BID ADDENDUM #3

DATE: June 5th, 2023
PROJECT: 15th Street Extension
PROJECT P.I. NO. 0015019
NUMBER:

REVISION SUMMARY
15TH STREET EXTENSION

TITLE **GRADING AND DRAINAGE PLAN**
 SHEET NUMBER **C3-00**

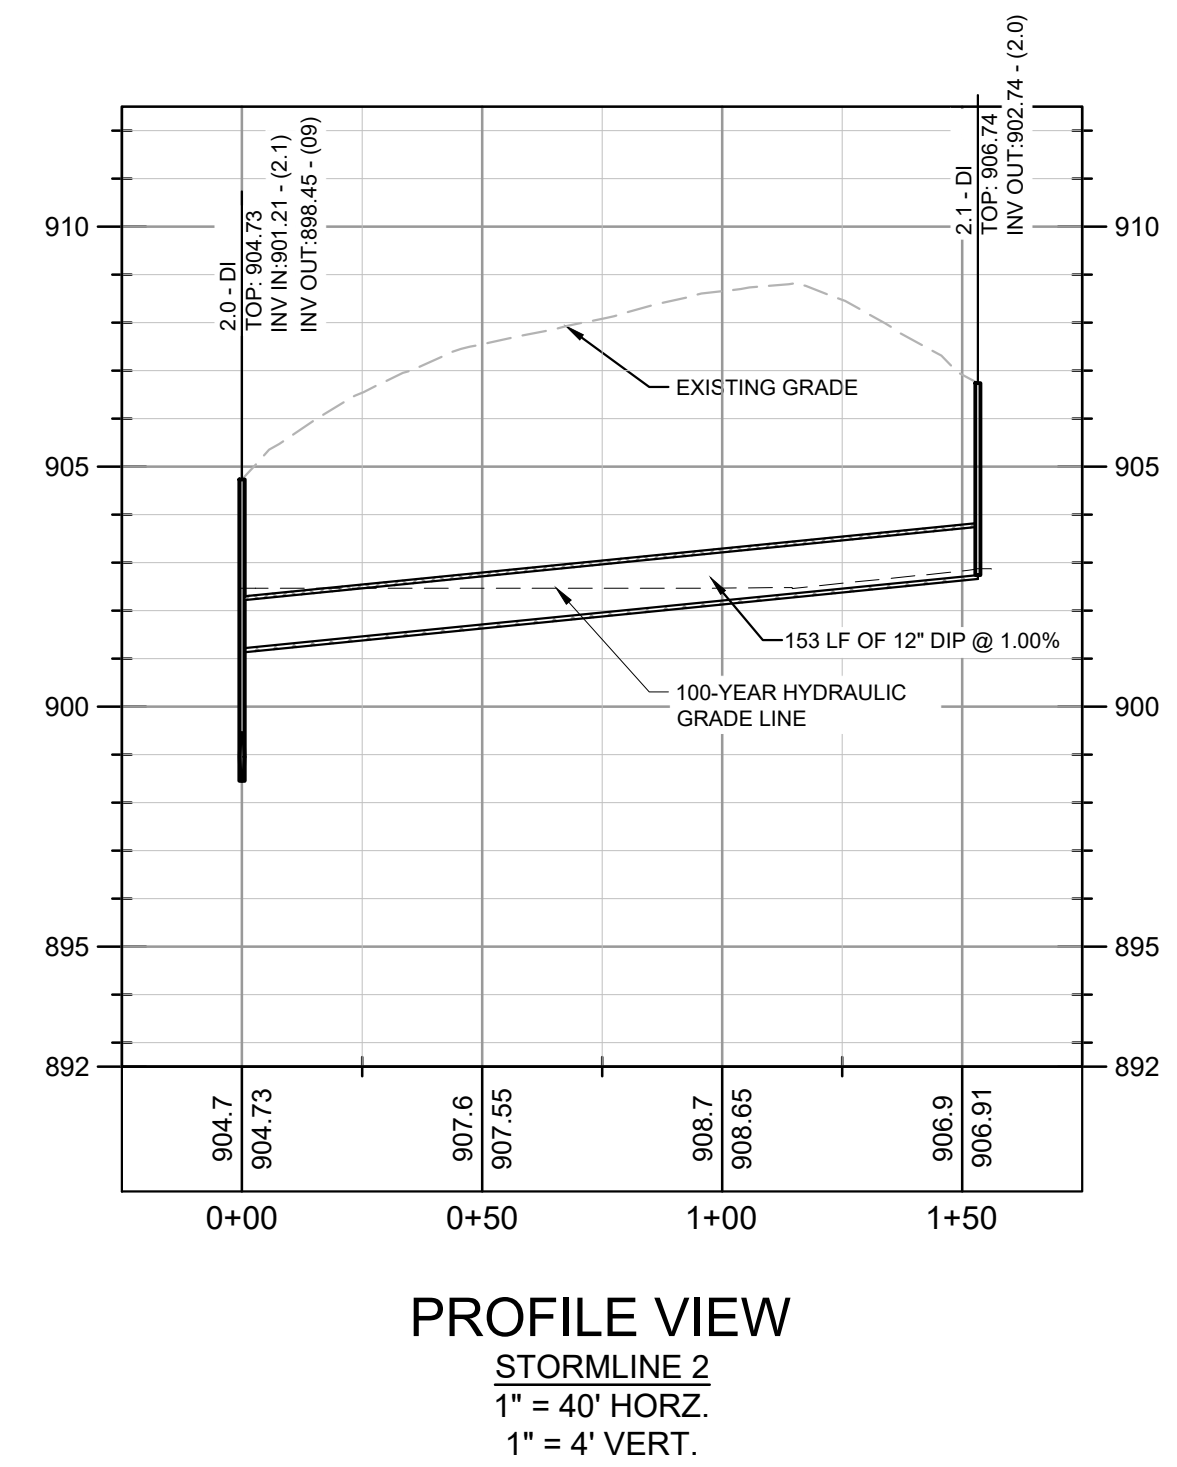
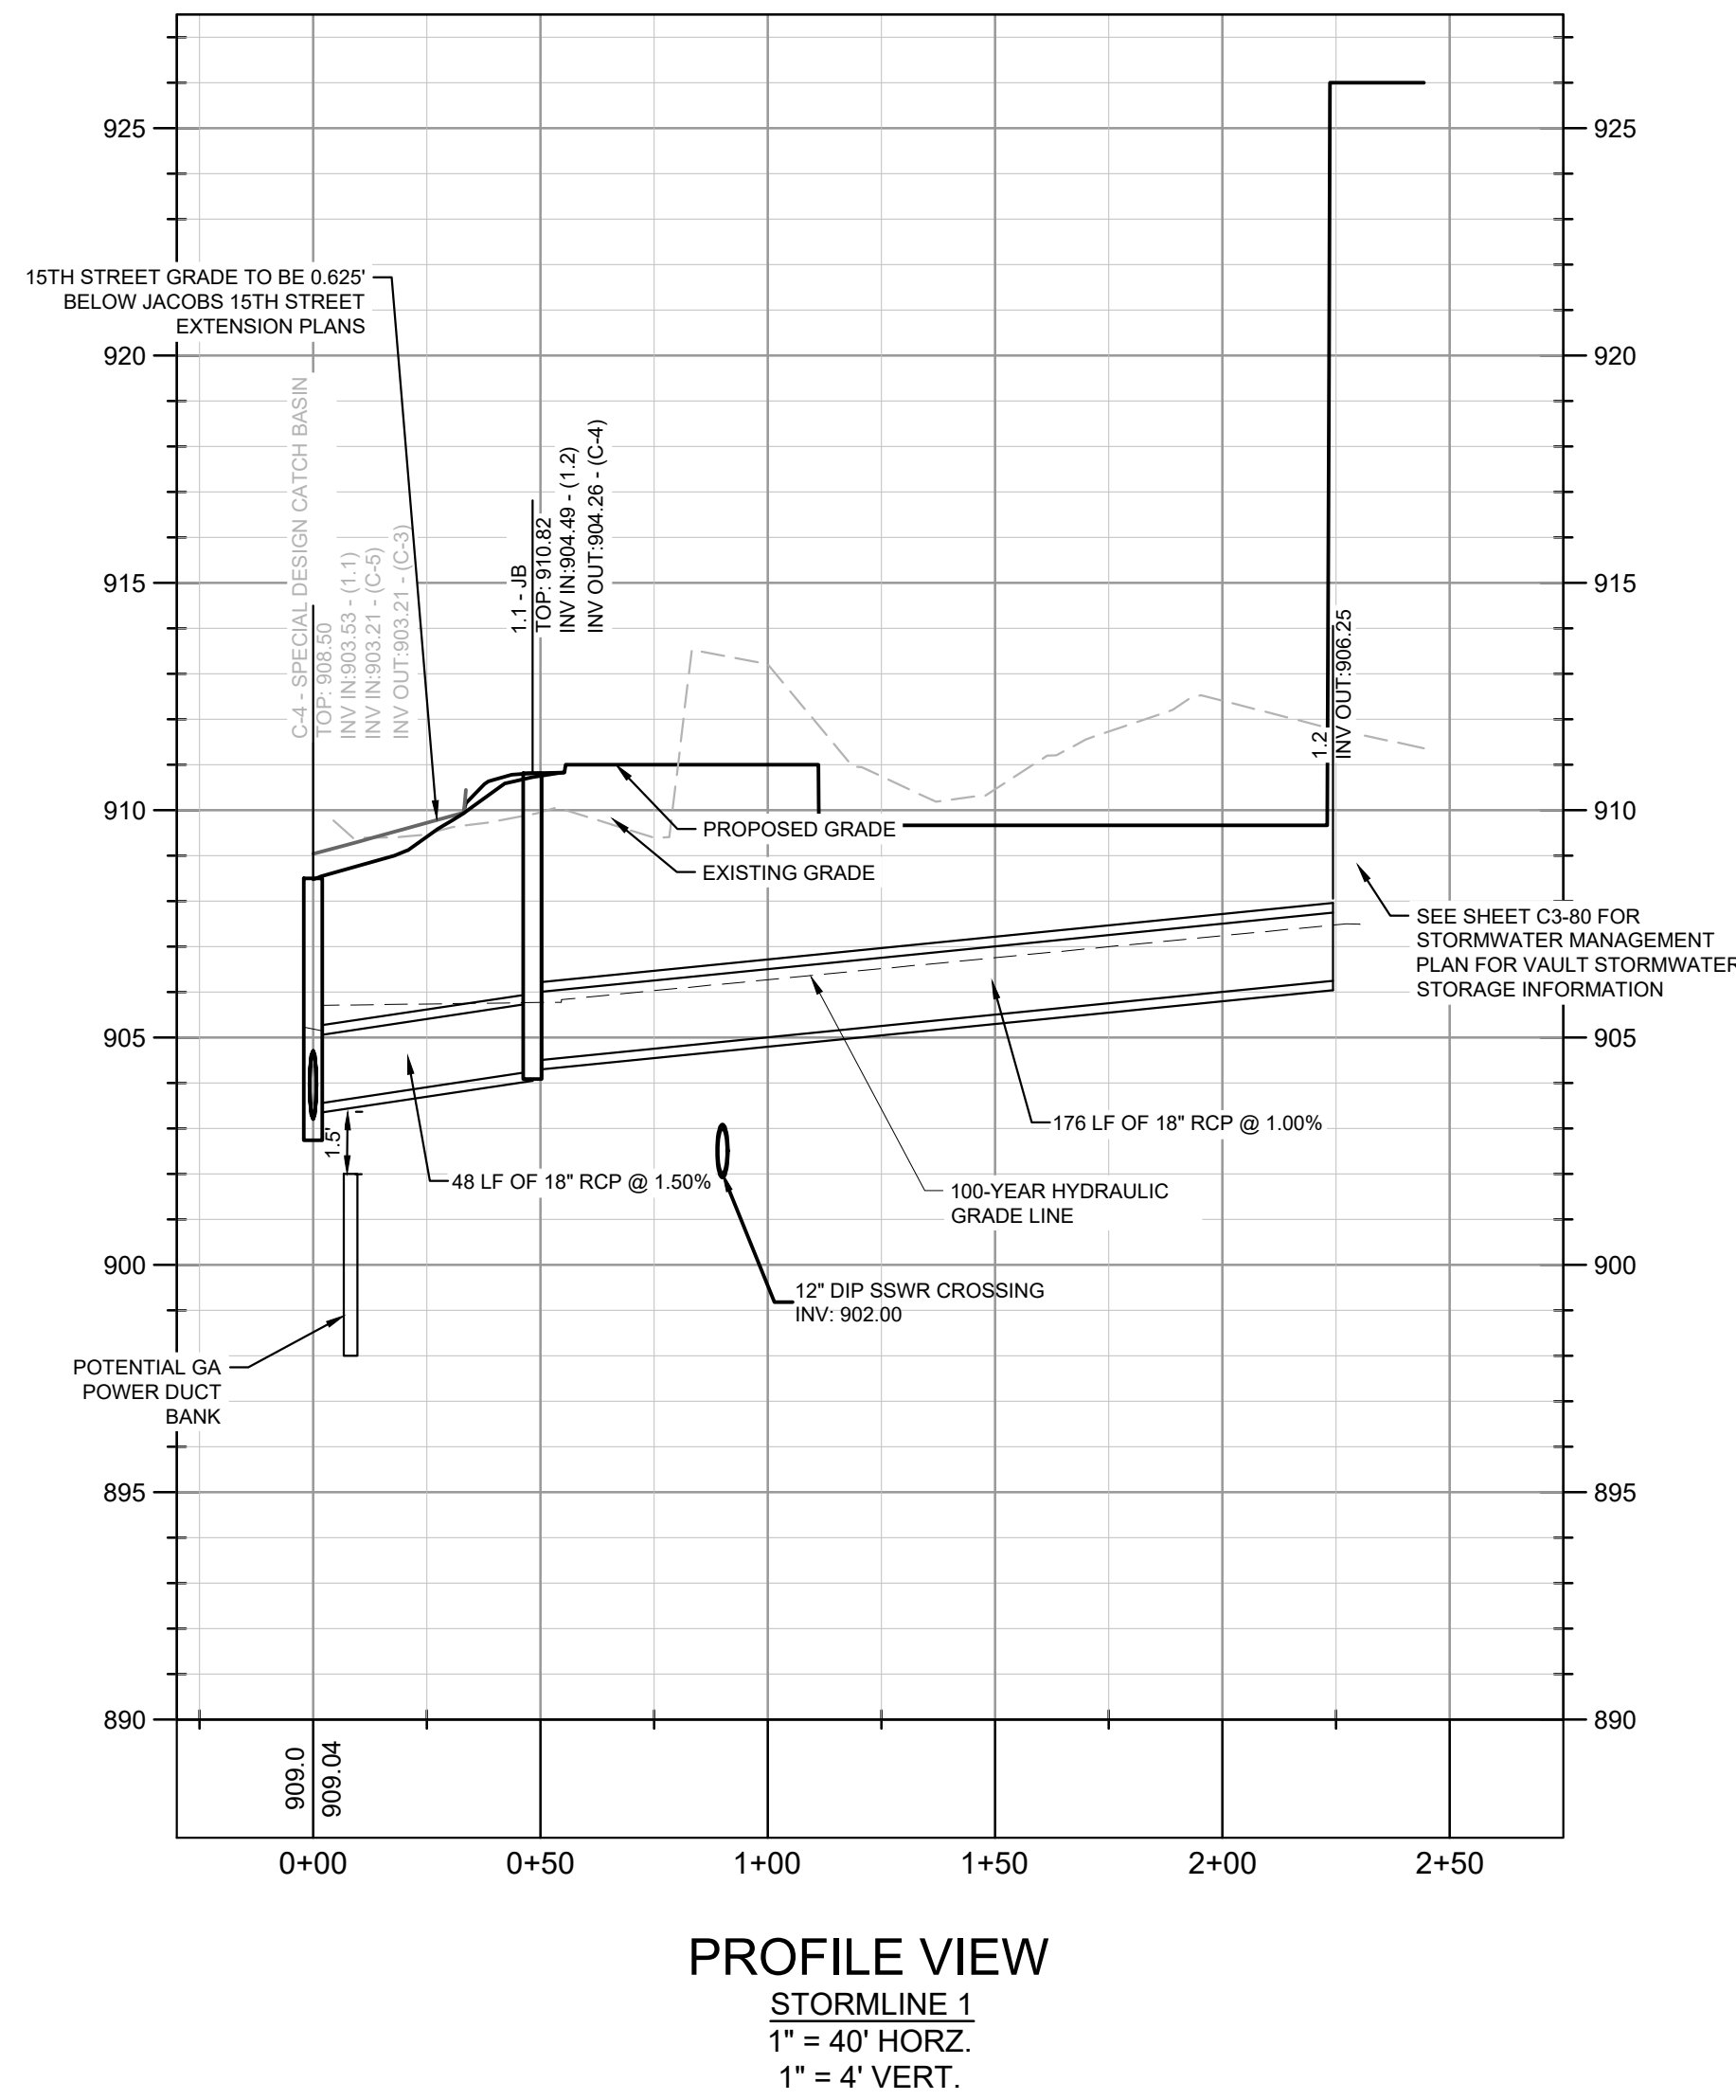
1. **Question:** The alternate bid appears to just be a run of 18" storm drain pipe between STA. 15+00 and 16+00. Is there a drainage profile available for the line coming from structure C-4 running south to the adjacent parcel (#4)?

Answer: See attached Hanover 1230 West Peachtree C3-00 and C3-50 Kimley Horn drawings for the subject 18in storm drain to be installed by Hanover prior to roadway construction.
